Technical Service Bulletin

| GROUP CAMPAIGN | NUMBER 23-01-017H |
| DATE MARCH 2023 | MODEL(S) Ioniq 5 Electric (NE1) |

SUBJECT: IONIQ 5 EV BATTERY CONDITIONING TO OPTIMIZE COLD DC CHARGING (SERVICE CAMPAIGN T9Q)

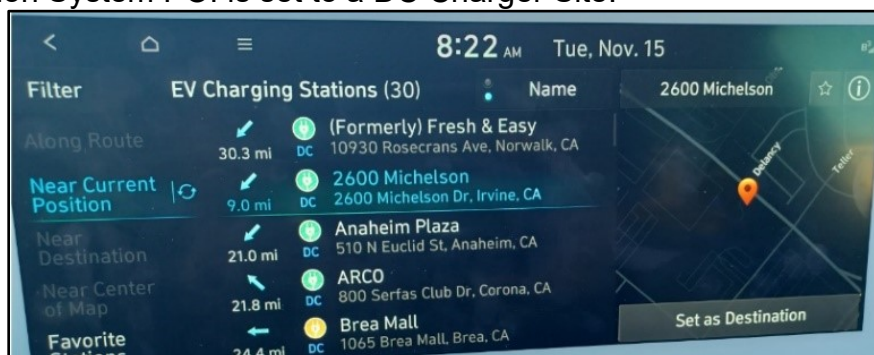
1. The Battery Conditioning must be enabled in the AVN display at the EV Settings Screen:

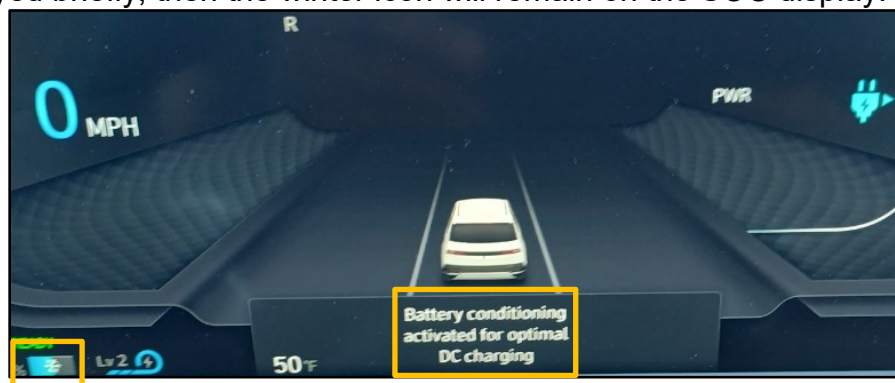
2. The Navigation System POI is set to a DC Charger Site.

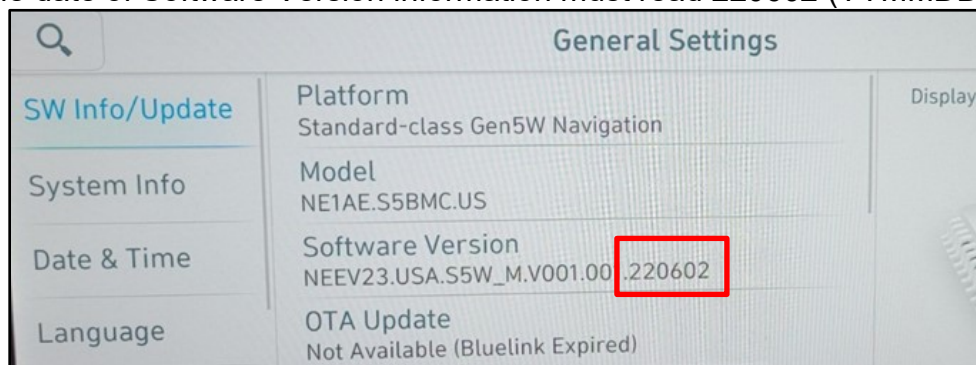
- a. Use the Auto Mode ID Check to verify the VCU ROM ID before updating the software.

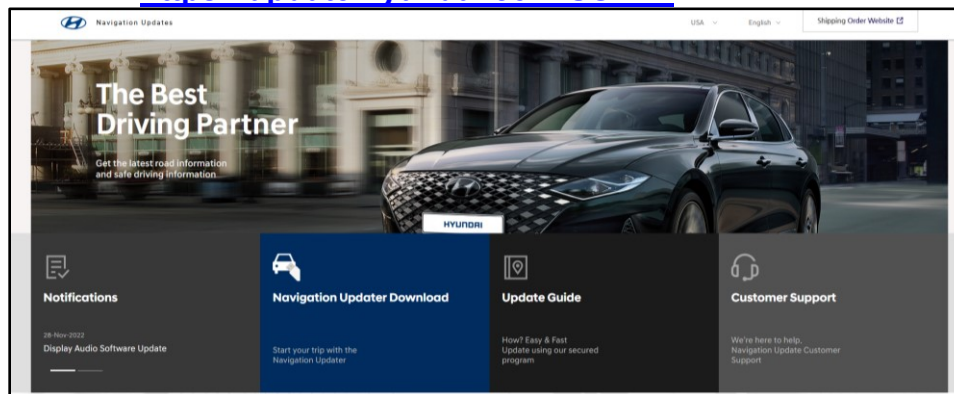
- Press the SETUP button on the trim below the display screen.
- Press General Settings in the menu displayed on the screen (if not displayed you may need to scroll down)
 - a. The date of Software Version information must read 220602 (YYMMDD)

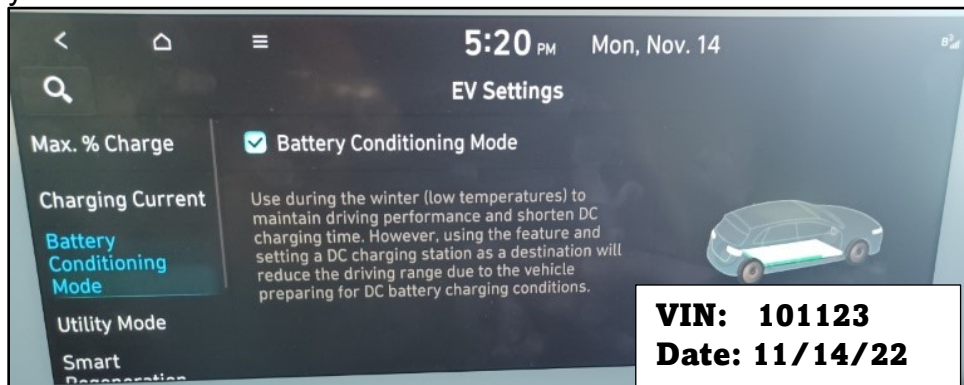
6. Confirm that the Battery Conditioning function is now present in the AVN EV settings screen.
